**METROPOLITAN DEVELOPMENT COMMISSION
HEARING EXAMINER**

Case Number: 2025-CAP-841 / 2025-CVR-841

Request: Modification of Commitments related to petition 2021-CZN-831 to terminate Commitment 30 (current commitment prohibits the installation of playsets or similar play equipment designed for children anywhere in the development), and to modify Commitment 32 to replace the word “shall” with the word “may” in the first line in reference to the Homeowner’s Association providing maintenance services including yard work, snow removal, and leaf cleanup (current commitment states that the Homeowner’s Association *shall* offer to provide maintenance services including yard work, snow removal, and leaf cleanup).

Variance of Development Standards of the Consolidated Zoning and Subdivision Ordinance to provide for front-loaded garages to consist of 77.4% of the façade at the front building line (maximum 30% permitted).

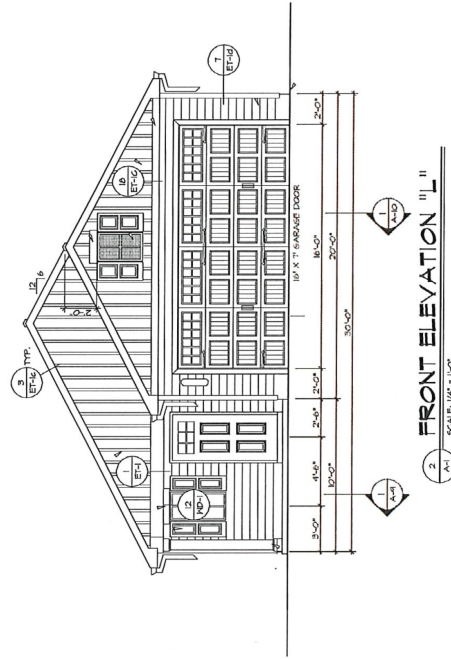
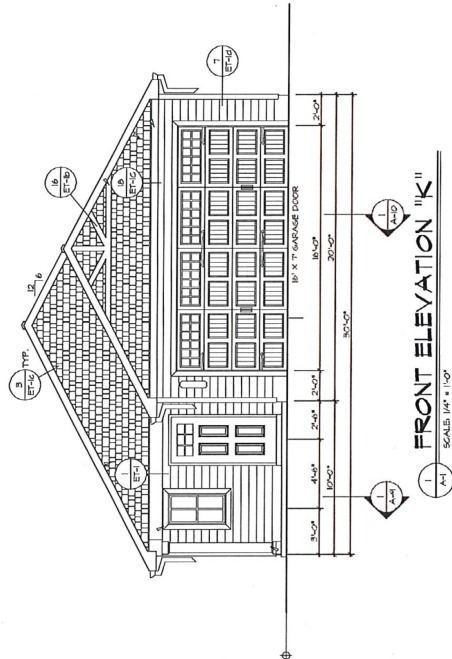
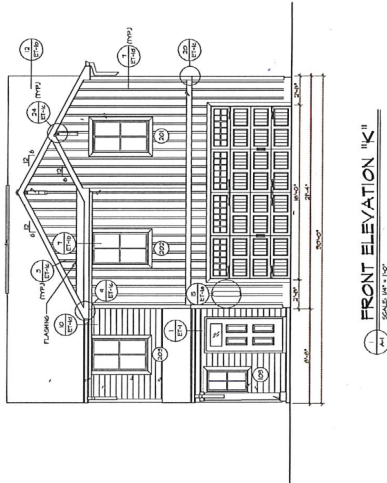
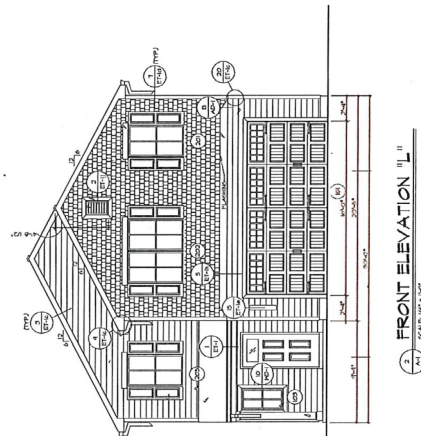
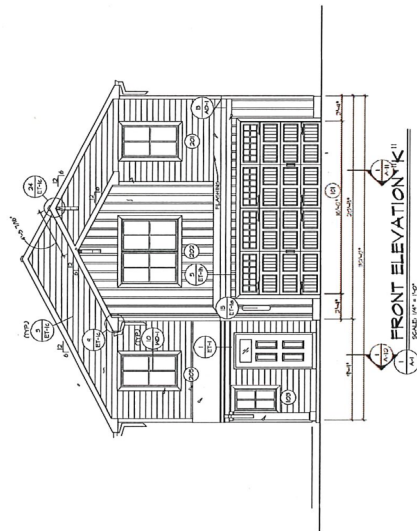
This request would provide for the front-loaded garages to consist of 77.4 % of the façade at the front building line when the Ordinance limits the percentage to 30% of the façade.

Limiting the front-loaded garage to 30% of the façade minimizes the impact of conflicts between pedestrians and vehicles and improves the safety pedestrians. It also results in the architecture of the dwelling to maintain a visual balance between the living area and the garage.

Recent submittals of garage door elevations minimizes the dominating visual impact of garage doors, but staff continues to be concerned with the safety of pedestrians in the neighborhood as more residents move into this community.
